Memo

Re: Site plan at 209 William Blount Drive.

Auto Physicians have submitted a site plan for an automobile service center at 209 William Blount Drive. This property is zoned C-commercial and is identified on tax map 067, parcel 248.07. This was a 3.7 acre tract that has been divided into a 1.28 acre lot and a 2.4 acre lot. The applicant is to provide a copy of the registered plat prior to the meeting. This property is within the growth boundary of Maryville.

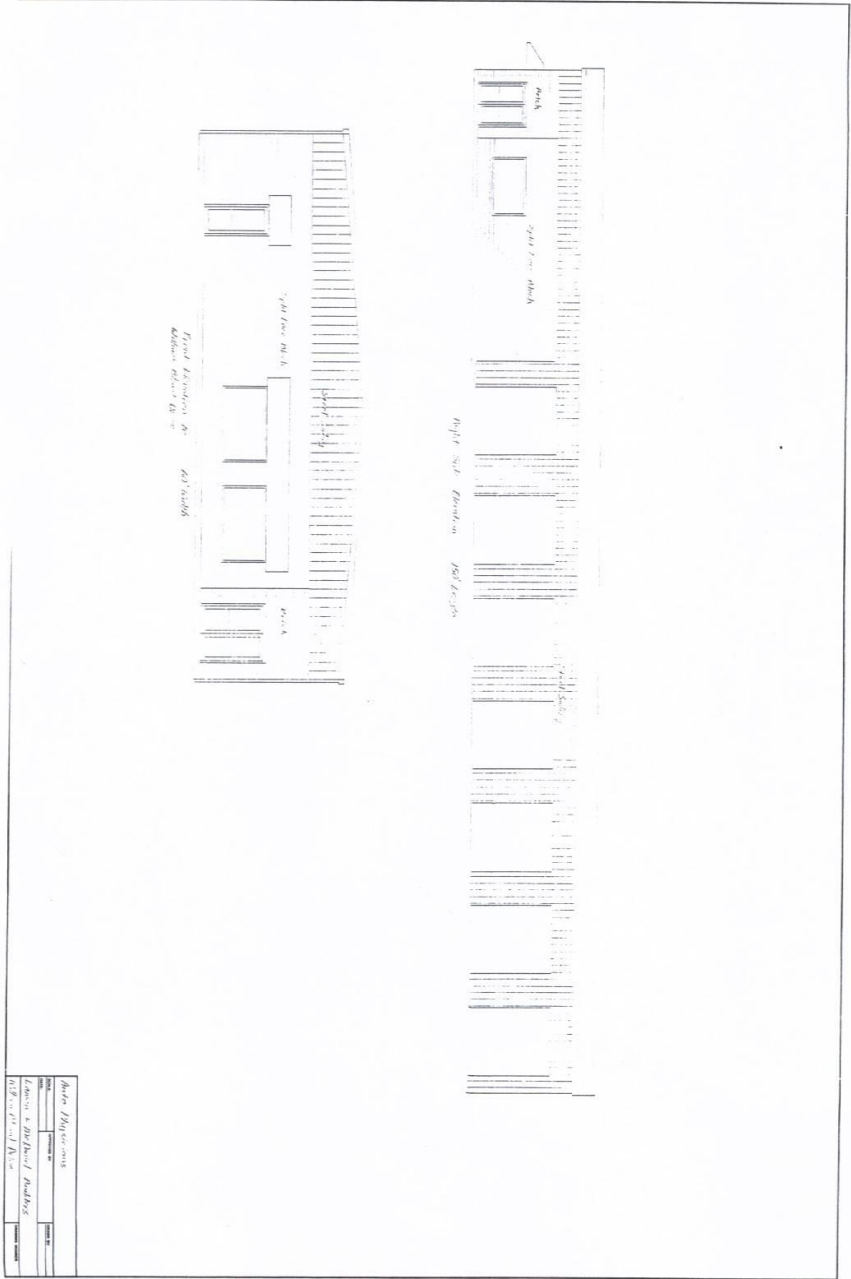
The structure is a 9,000 s.f. building that will house an office/Lounge area and the remainder will be service bays for automobiles. The site plan does indicate that all building setback requirements will be met by the proposed structure. The front of the building, fronting William Blount Drive, will consist of split block, brick, steel siding, and glass. The corner of the building, that will be covered with brick, will be on an angle and includes an entrance to the building. The door on the opposite side will be covered by an awning as well as the windows in front. These design elements will meet the design requirements found in section 7.15. The side of the building that will be most visible from William Blount Drive will consist of Brick (the same corner of the front), split face block, glass, steel siding, and seven garage doors. Our design requirements state that side wall plans shall be

staggered by occasional changes in surface planes or changes of materials or architectural features to avoid monolithic “box” appearance. It also states that walls and roof visible to public roads shall have changes of wall and roof planes with at least a three (3) feet projection or recess no less than every thirty (30) feet spacing, both horizontally and vertically. The builder has indicated that most of the buildings sides will not be visible from the road once the grade work is completed, if so I believe the structure shown will meet our requirements. If the sides of the building are visible from William Blount Drive then I believe the three (3) feet projections or recess should be added. This may be accomplished by the addition of awnings over the garage doors or other projections along the length of the building.

When reviewing the rest of the site you will find that the parking will include 50 parking spaces 7 of them are for compact vehicles and 2 handicapped spaces. This design is based on 1 parking space per 200 square feet of floor area and will meet our requirements. The property on the North side is zoned commercial and does not require buffering. The property on the South side is commercial back to about 235 feet and does not require a buffer. The lot that houses the proposed business is about 250 feet deep, so the last 15 feet on the south side should be buffered from the abutting residential property if the remaining natural vegetation does not achieve a full screen. The site plan does indicate a complete drainage plan and erosion control plan. This site will also be on a subsurface sewage disposal system. All required permits from the Storm Water Department and the Environmental Health Department must be obtained prior to construction. A TDOT permit is required for the driveway connection onto William Blount Drive. The applicant has stated that this permit has been issued and he will provide me a copy prior to the meeting. Below are the site plan and the elevations for this project.
